ADDENDUM 7 REVISED: 08/20/07ab
 REVISED: 05/21/07
 REVISED: 03/07/07

RENOVATE OFFICE BUILDING

1ST FLOOR STRUCTURAL PLAN

ST. TAMMANY PARISH ADMIN. COMPLEX
 520 OLD SPANISH TRAIL
 SLIDELL, LOUISIANA

FIRST FLOOR STRUCTURAL PLAN

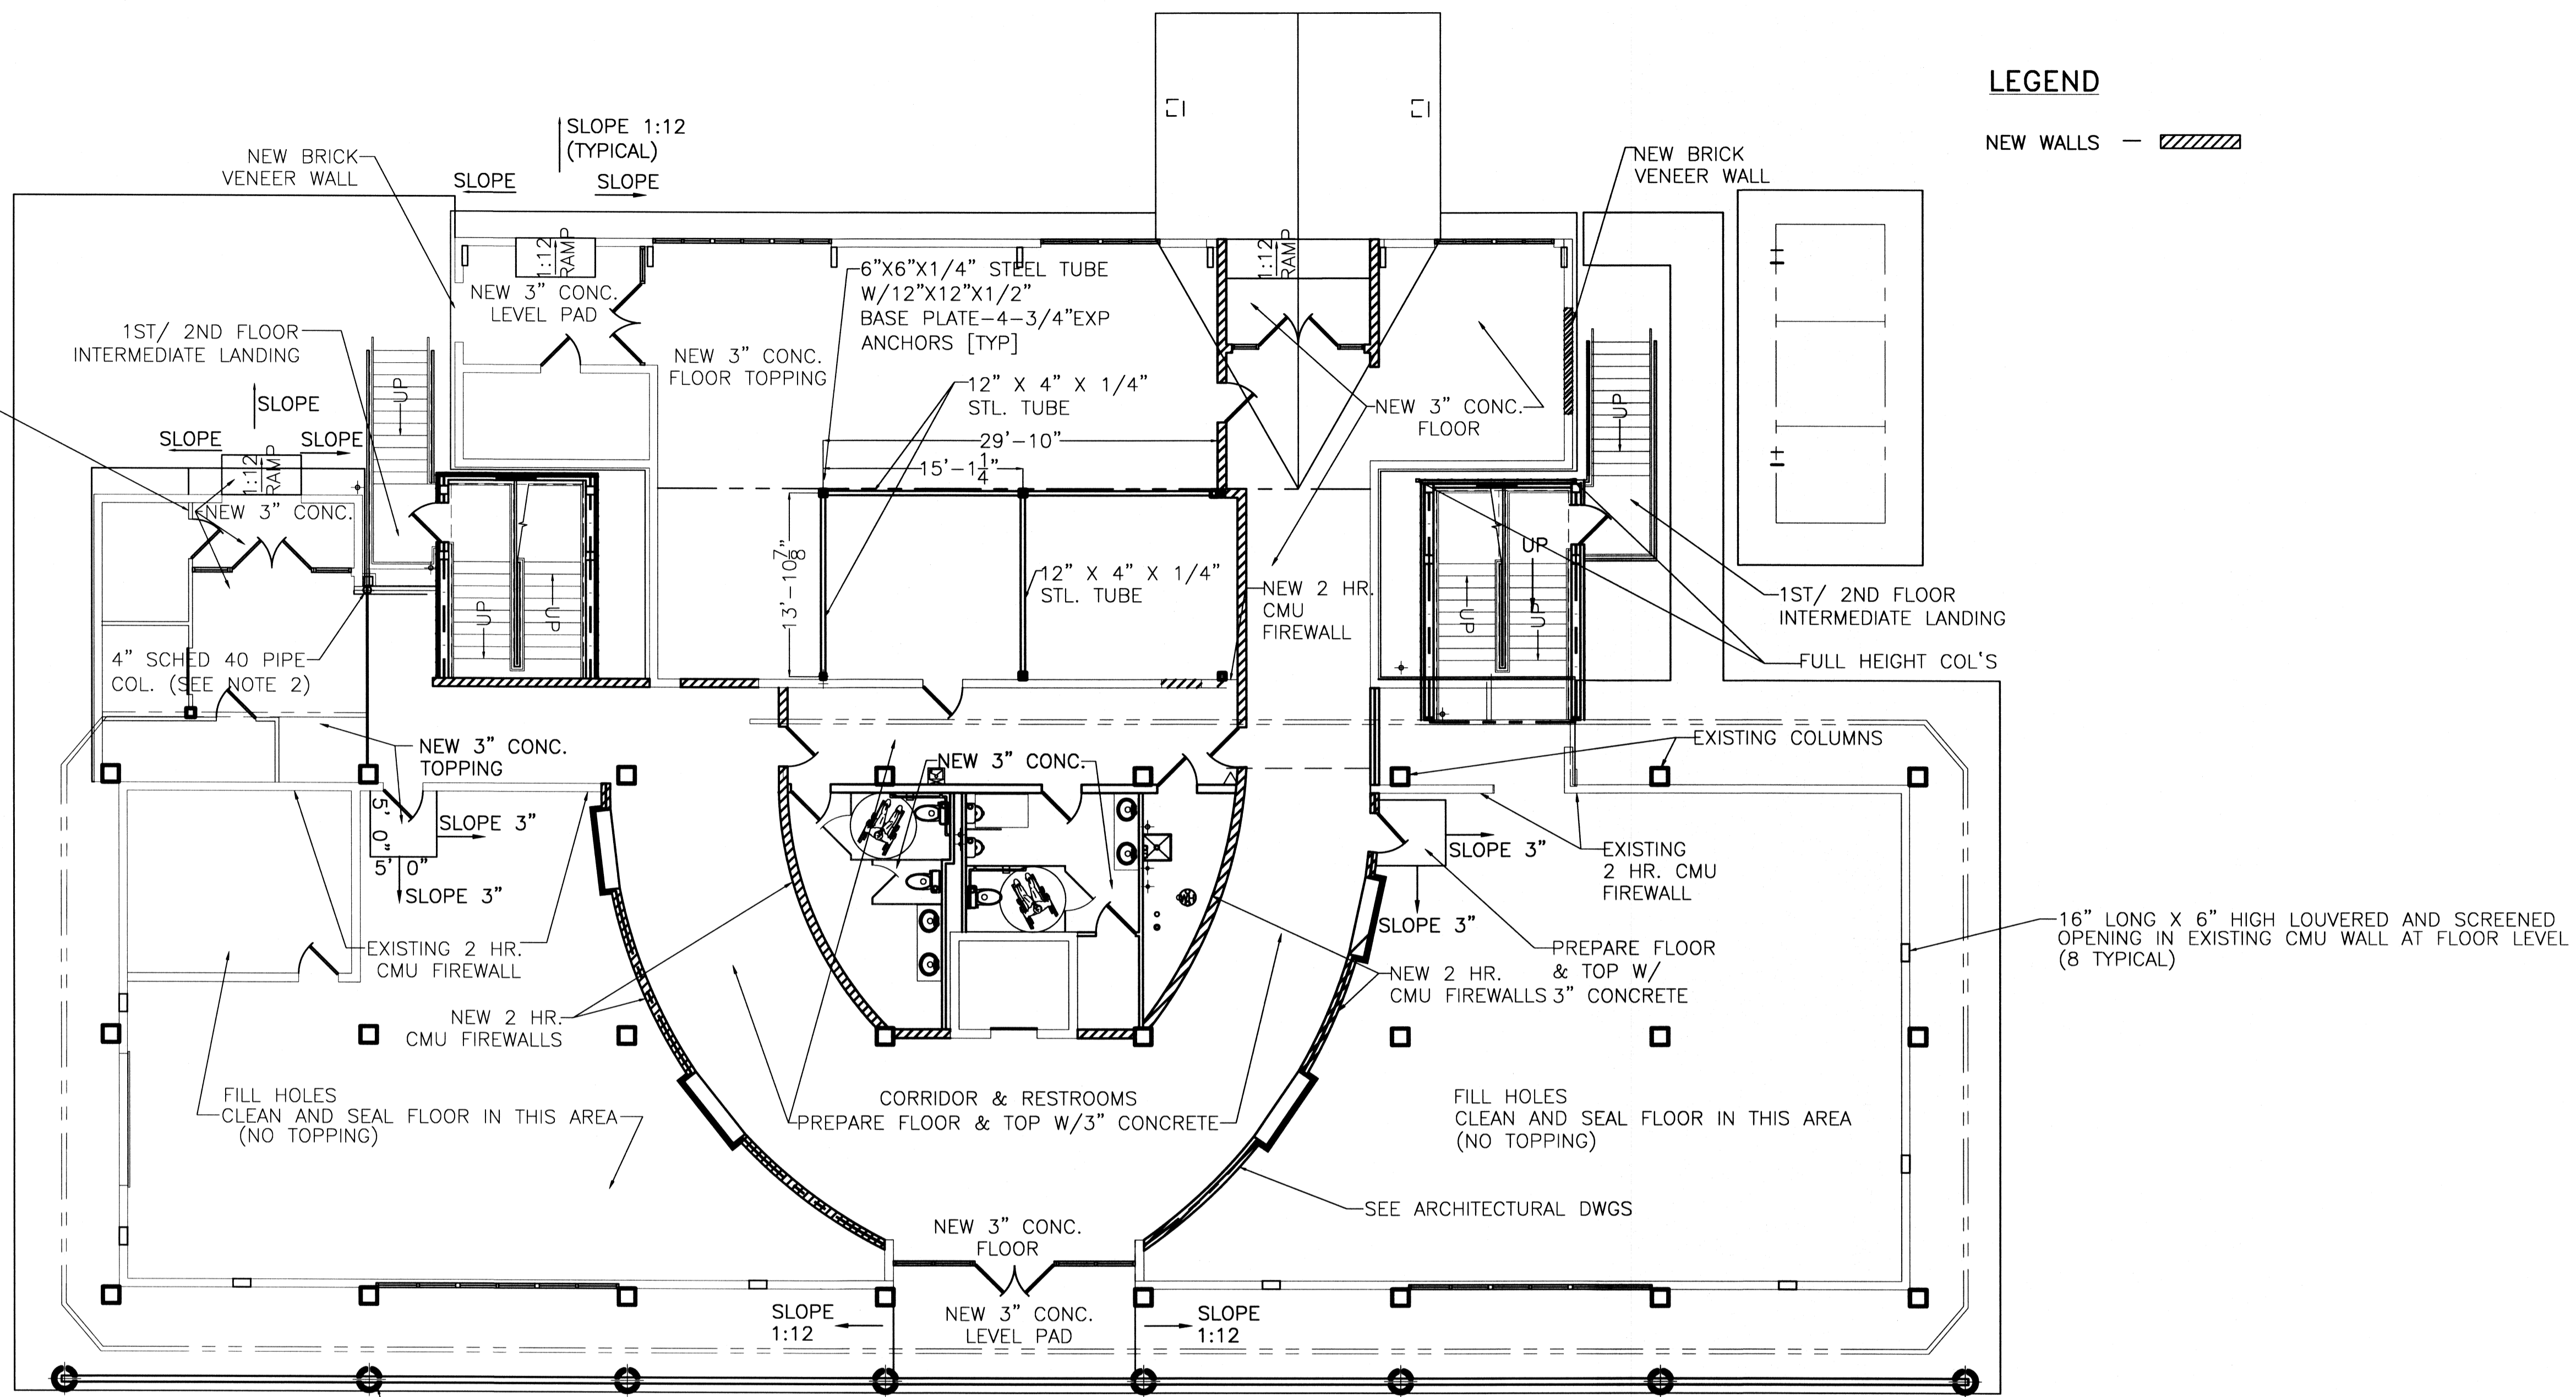
CLOSE THE OPENING WITH LIGHT GAUGE METAL FRAME AND SHEATHING TO MATCH EXISTING ELEVATOR TOWER

- ELEVATOR CONTRACTOR SHALL RELOCATE 1ST FLOOR STOPS TO ACCOUNT FOR RAISING FLOOR 3".
- INSTALL 4" SCHEDULE 40 PIPE COLUMN W/ 6" X 8" X 1/4" PLATE T & B @ FLOORS 1 THRU 6 TO SUPPORT EXISTING HORIZONTAL WF BEAM PRESENTLY ATTACHED TO VERTICAL COLUMN AT EXTERIOR OF WALL. WELD NEW COLUMN TO BOTTOM OF EXISTING BEAM ABOVE. REMOVE EXTERIOR COLUMN, TRIM BEAM TO WALL AND ADD NEW SIDING TO MATCH. PATCH INTERIOR WALL (4 LAYERS OF 5/8" GYPSUM W/ GYP. BOARD).
- ALL MISC. STEEL SHALL BE ASTM A36.
